Shotover WWTP Enforcement

Technical Assessment - Shotover WWTP
Compliance

December 2024

Otago Regional Council
70 Stafford St
Dunedin 9054

Figure 2.1: Total Suspended Solids in Shotover WWTP Effluent

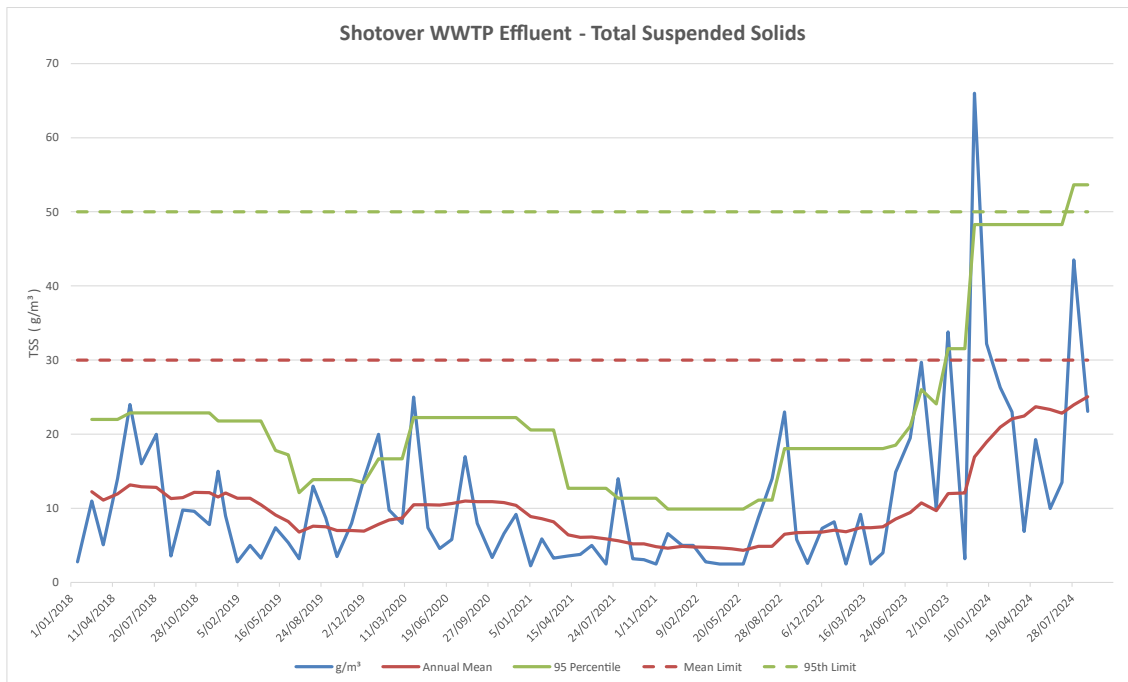
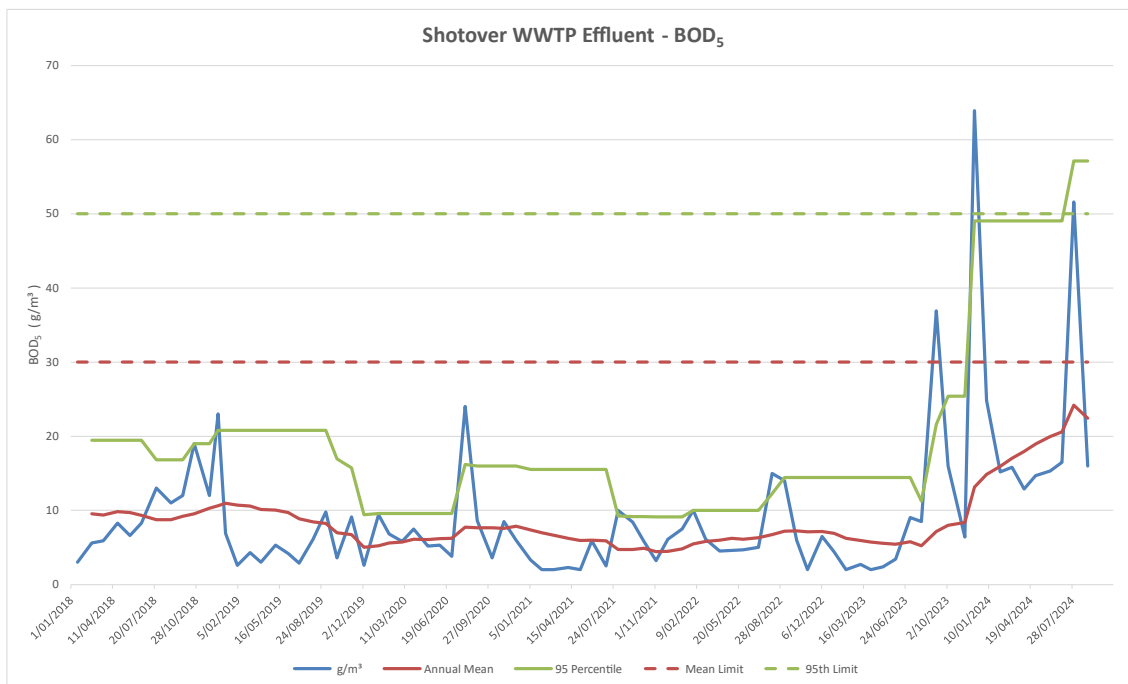
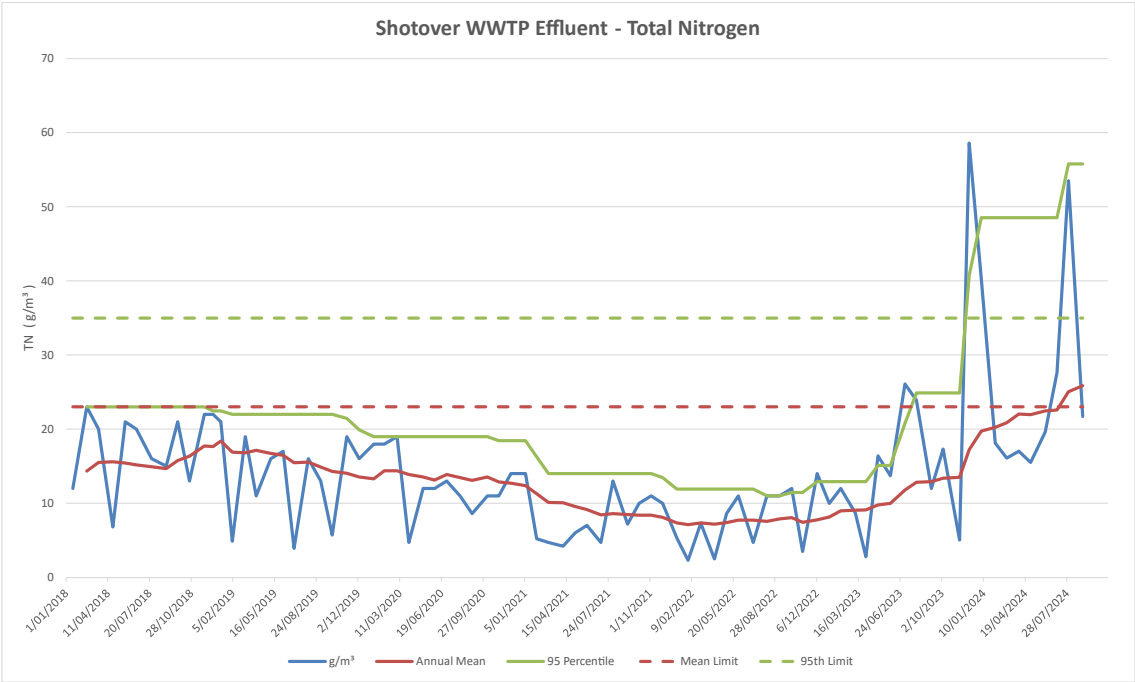
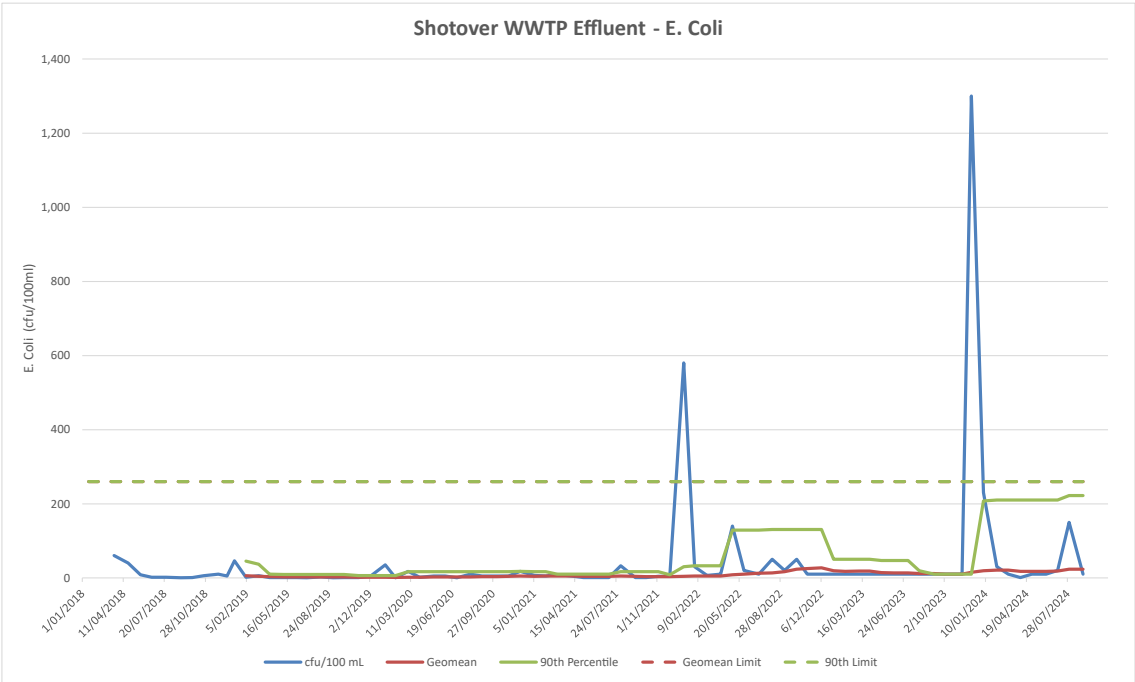
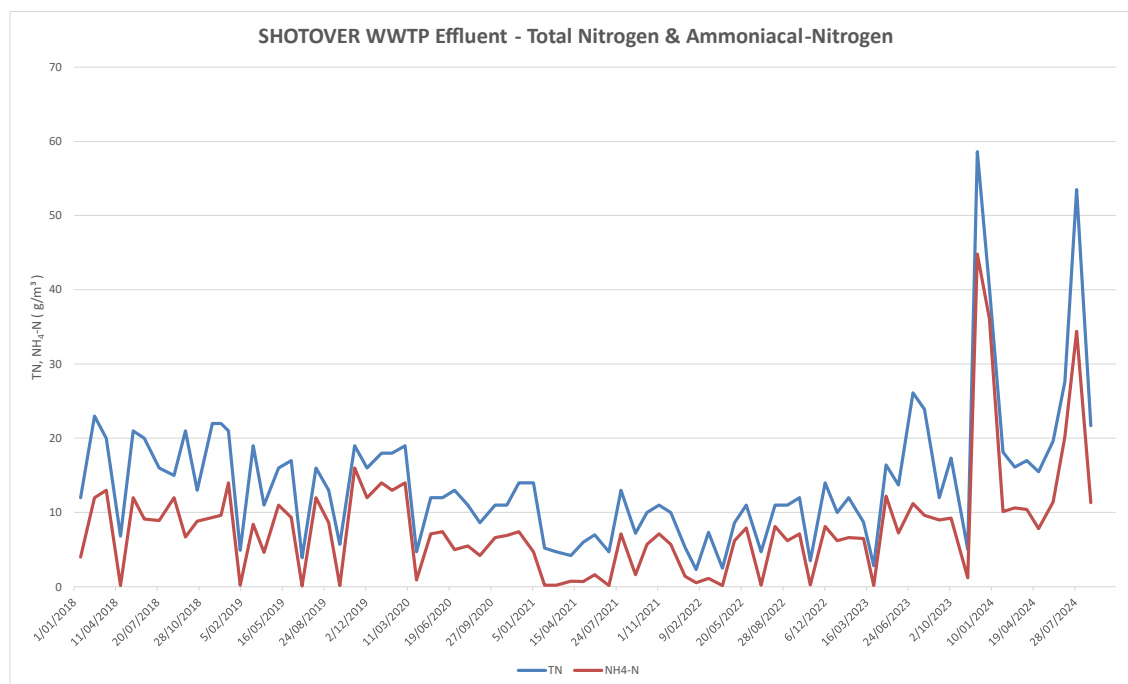
The results show that there was a high TSS in the effluent from the plant on the 7 December 2023 and 1 August 2024, and that this correlates with the elevated cBOD₅, Total Nitrogen, Total Ammoniacal-Nitrogen, and E. coli results. It seems likely that the low DO and the loss of solids from the MLE process contributed to the loss of nitrification and elevated ammonia levels seen in the December 2023 sample.

By the 4 April 2024 the results appeared to be trending downwards towards normal levels again, suggesting the issues had been resolved and the plant was approaching a more stable performance. However, the results from July and August 2024 suggested that this was not the case, as discussed in Section 2.4.6.

Figure 2.8: Groundwater Bore 8 Concentrations (Effluent TN shown for comparison)

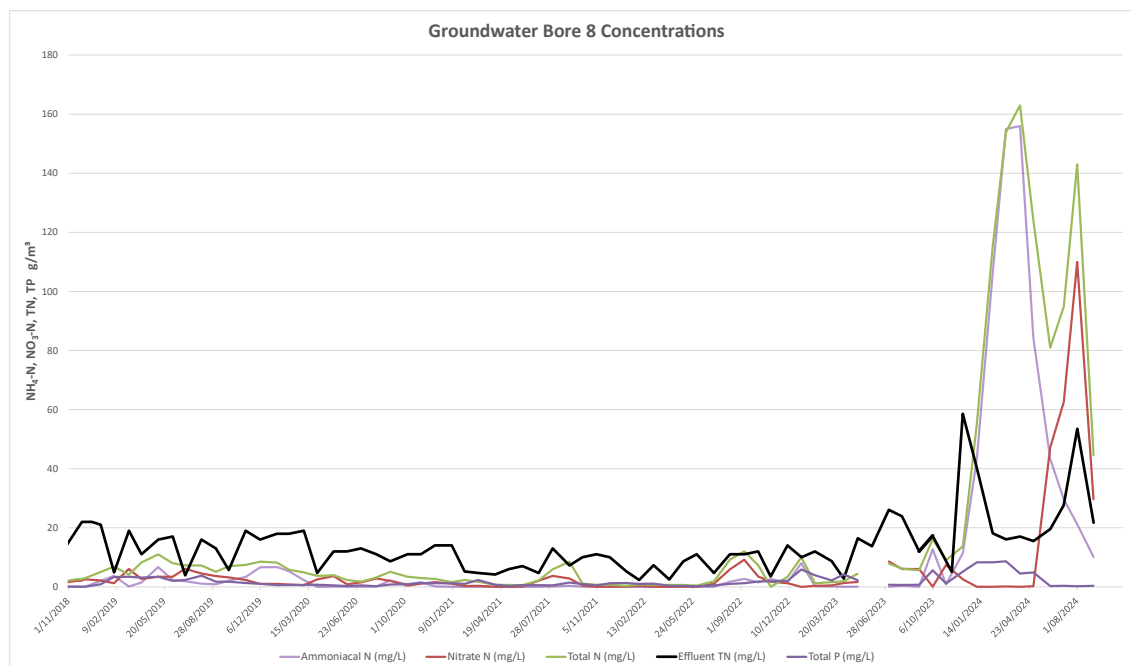
However, the down gradient bore 8 showed a disproportionate and delayed response to the effluent peak seen in December 2023.

Generally, one would not expect the total nitrogen concentration in the bore to exceed the concentration in the discharged effluent by this magnitude (it is nearly 3 times higher). Nitrogen is converted from one form to another depending on the environmental conditions (eg from ammonia to nitrate, and from nitrate to nitrogen gas) but the total nitrogen is conserved or reduced (for example if ammonia or nitrogen gas is stripped from the liquid phase). For the total nitrogen to increase like this would suggest another source is contributing significant ammonia to the groundwater.

One possible explanation is that there has been a significant discharge of organic solids (consistent with the loss of biological solids from the WWTP) deposited in the disposal field that have accumulated and then decomposed. Organic solids are broken down by microorganisms to produce ammonia. This ammonia can then be biologically converted to nitrate under aerobic conditions, which may be what we are seeing in the June sample (ammonia is decreasing whilst nitrate is increasing).

It is not clear why the same pattern has not been seen in the other bores. The effect seems to be concentrated in the down gradient Bore 8.

The ammonia in the bore is on a downward trend and it would appear that nitrate levels have also peaked and are now falling. It is expected that this should continue, provided there is not another breakthrough of solids from the plant.

Figure 2.10: Total Nitrogen in Groundwater Bores and Shotover WWTP Effluent

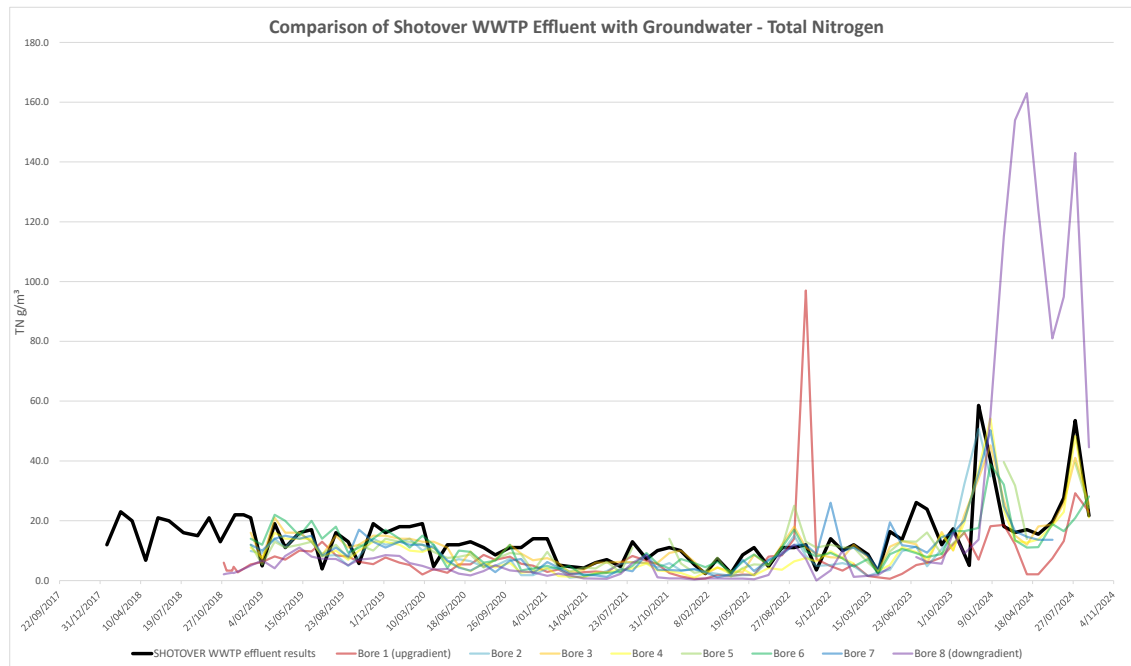
Generally, there is a reasonable correlation between the WWTP effluent total nitrogen concentration, and the concentrations measured in the groundwater bores. As discussed previously, a disproportionately high peak was observed for bore 8 peaking in April 2024 at 163 mg-N/L.

It is noted that there was a peak in total nitrogen seen in the up gradient bore 1 in October 2022 that was not seen by the other groundwater bores. However, the ammoniacal nitrogen sample for bore 1 (Figure 2.7) did not respond in a similar fashion for the same time period, suggesting the datapoint could perhaps have been an outlier.

Figure 2.11: Total Phosphorus in Groundwater Bores and Shotover WWTP Effluent

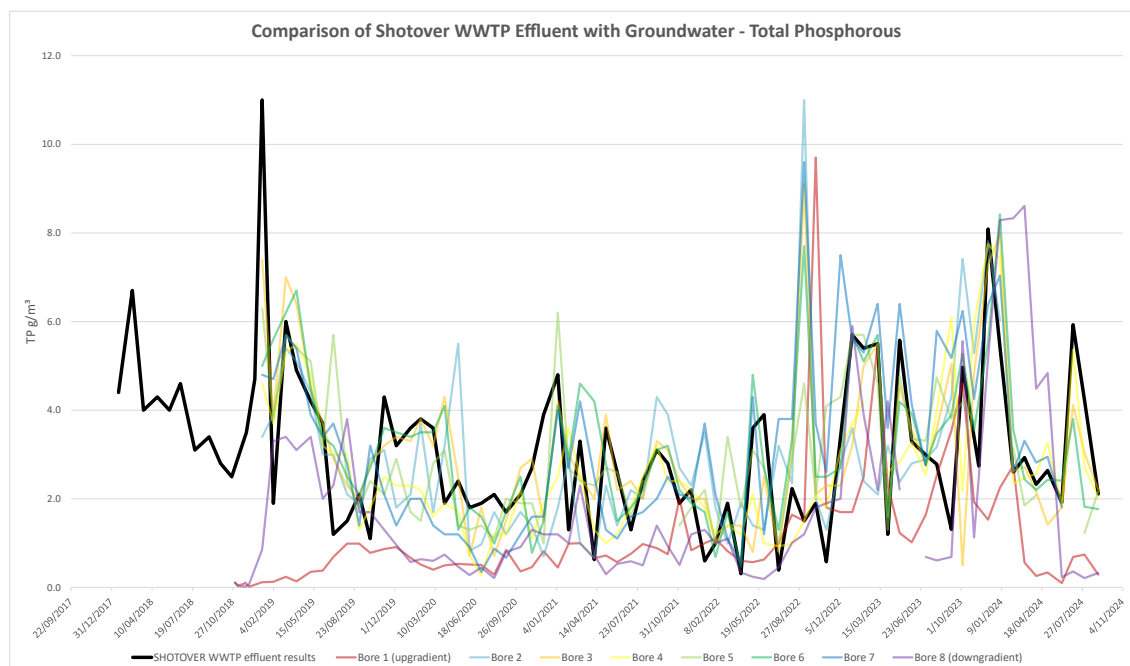
The concentration of total phosphorus in the groundwater samples have had similar concentrations to the Shotover WWTP effluent sampling data, with high levels of variation in 2023. However, there was a disproportionately high peak of total phosphorus recorded for the groundwater samples, specifically bores 2, 3, 4, 6 and 7 in September 2022, as well as a delayed peak from bore 1 in October 2022, that were not reflected in the Shotover WWTP effluent for the same time periods. The reason for this peak is not known.

Figure 2.12: E. coli in Groundwater Bores and Shotover WWTP Effluent

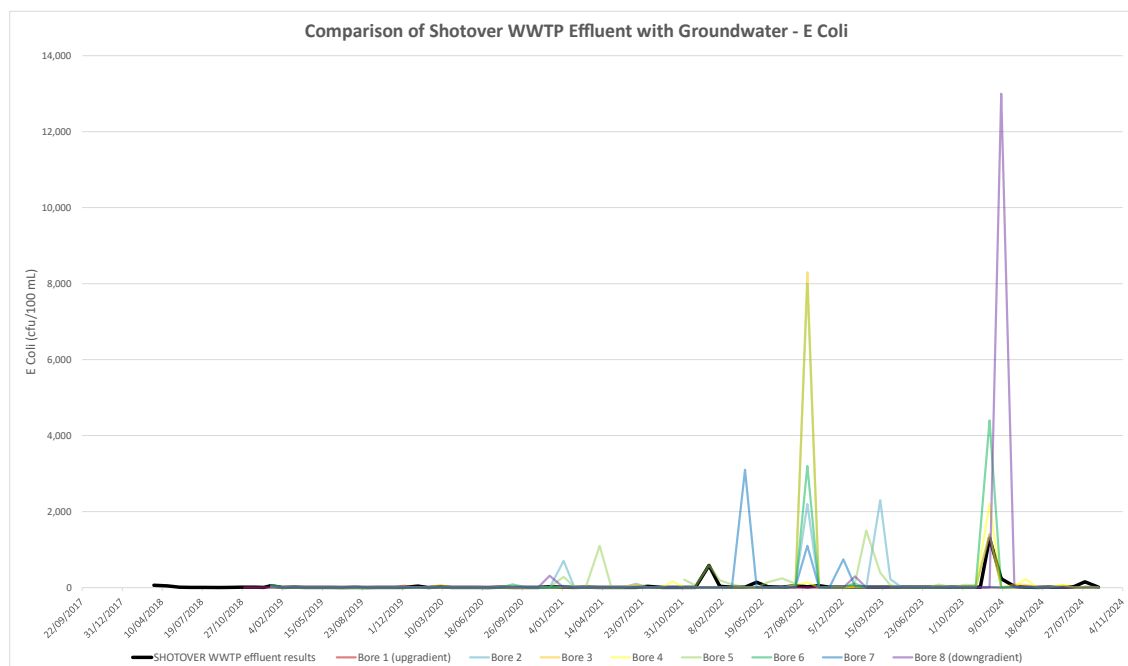
The E. coli levels in the groundwater samples are shown to have increased variability in the latter half of the sampling period, with a large spike observed in September 2022 for bores 2, 3, 5, 6, and 7. This spike is not reflected in the E. coli level for the Shotover WWTP effluent in the same time period which was found to be 20 cfu/100mL.

The peaks in E. coli concentration observed in the groundwater samples for January 2024 can be correlated to a similar peak in E. coli observed in the Shotover WWTP effluent for January 2024. However, the response in borehole 8 again seems disproportionately large and delayed.
